SUBDIVISION REPORT - CONCEPT/USE ON REVIEW

▶ **FILE #:** 7-SA-21-C
7-C-21-UR

▶ **SUBDIVISION:** MISSION HILLS

CONCEPT GRADING PLAN AND ROAD PROFILE

Project: 330.018
 Sheet: CP2
 Date: 05/21/21
 Scale: 1"=40'

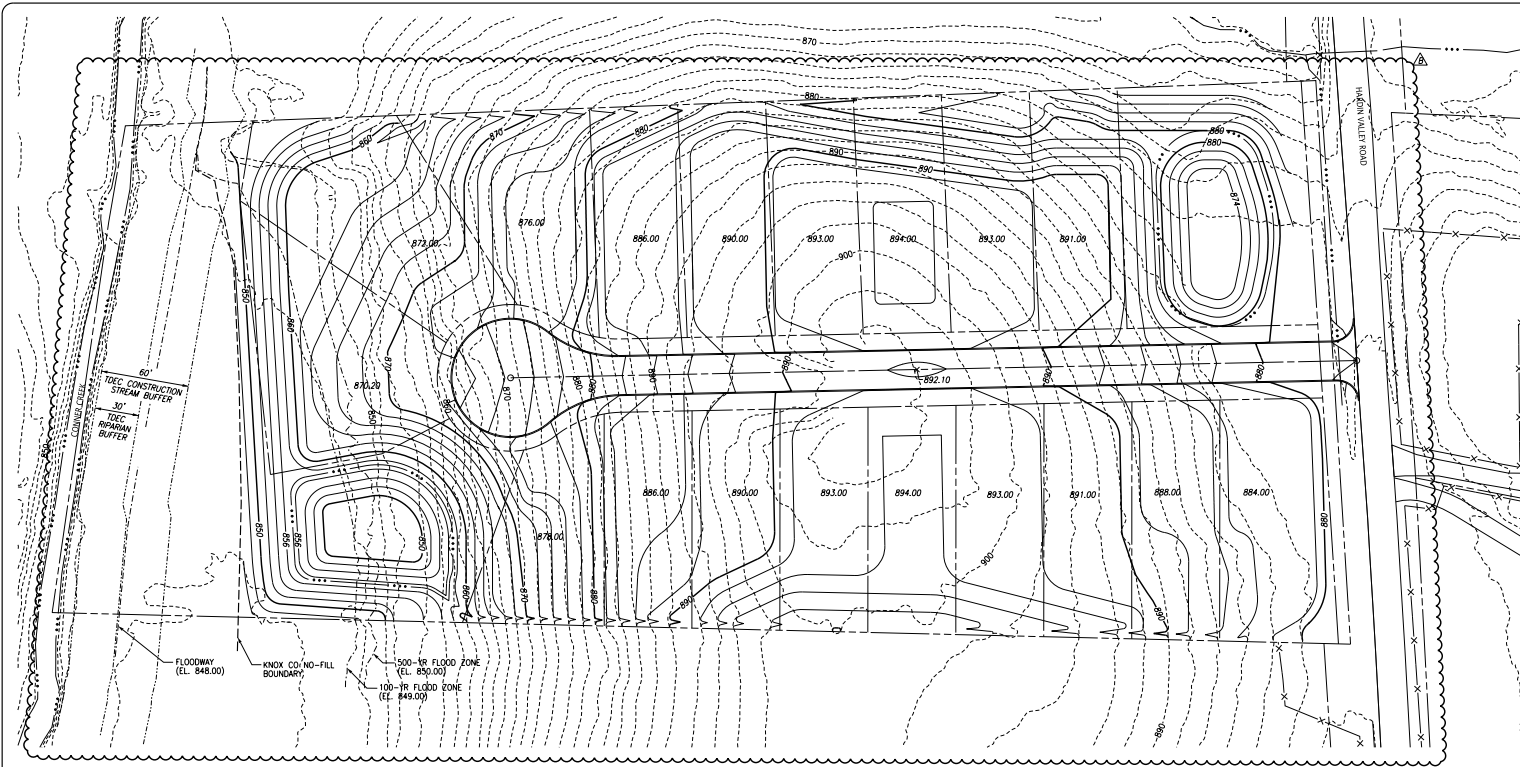
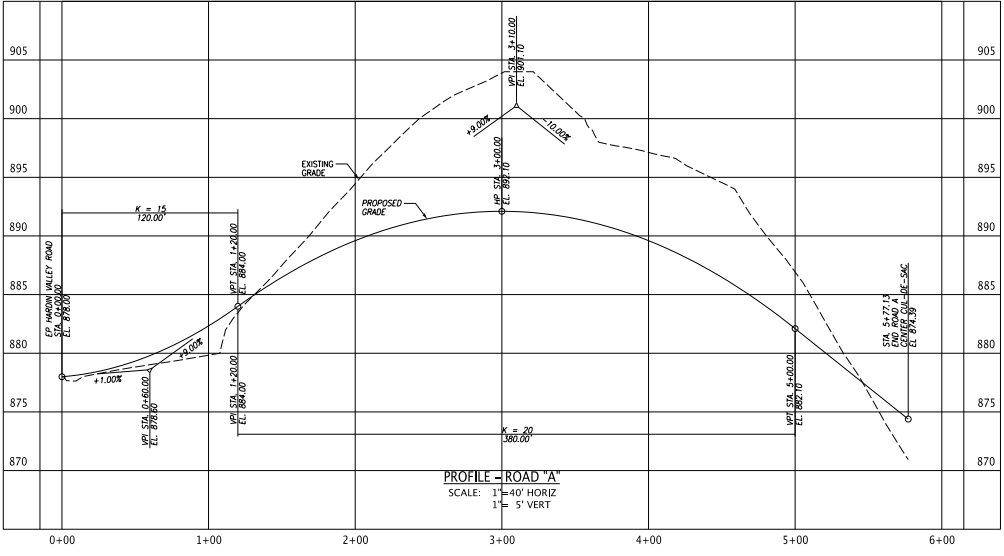
- 1) REDUCE THE VERTICAL CURVE (CREST) K VALUE FROM 25 TO 20 AT VPI STA 3+10.00 ON ROAD 'A'.
- 2) REDUCE THE MINIMUM DISTANCE BETWEEN MISSION HILL LANE AND ROAD 'A' FROM 400-FT to 343-FT.
- 3) REDUCE THE VERTICAL CURVE (SAG) K VALUE FROM 25 TO 15 FOR THE INTERSECTION OF ROAD 'A' AND HARDIN VALLEY ROAD.

The connecting vertical curve ("k value") is the transition of the grade of Road 'A' from 9 percent to 1 percent it approaches the Hardin Valley Road intersection. The lower the k value, the more abrupt the transition between the two road grades. At intersections with a classified street (collector or arterial), the minimum k value is 25 which allows for a smoother transition from the smaller local road to the larger classified street. This larger k value also allows the classified street to be expanded in the future and the new road grades to be more easily tied in the side streets. For this request, if the existing right-of-way for Hardin Valley Road is 40-FT, the County does not anticipate the need for additional right-of-way acquisition and the k value of 15 should not impact the ability to tie Road 'A' back into the new intersection nor greatly impact lot 18. If the Hardin Valley Road right-of-way is less than 40-FT, the County believes lot 18 could be impacted because of the need to reconstruct more of Road 'A' to tie in the grades properly, as well as needing to grade into the property more along the Hardin Valley Road frontage to accommodate the expanded road.

C. Approximately 3.83 acres of the 6.98-acre site is within the Hillside Protection (HP) area (see the attached slope analysis). The maximum recommended land disturbance within the HP area is 2.6 acres (approximately 68 percent of the HP area). The grading plan (sheet CP2) shows that essentially 100 percent of the HP area on this site will be disturbed.

▶ **APPROVE** variances 1 and 2 on the recommendations of the Knox County Department of Engineering and Public Works and because the site conditions restrict compliance with the Subdivision

APPROVE variance 3 only if the existing or dedicated right-of-way for Hardin Valley Road is 40-FT from the road centerline and the peripheral setback for lot 18 is no less than 30-FT along the Hardin Valley Road frontage.
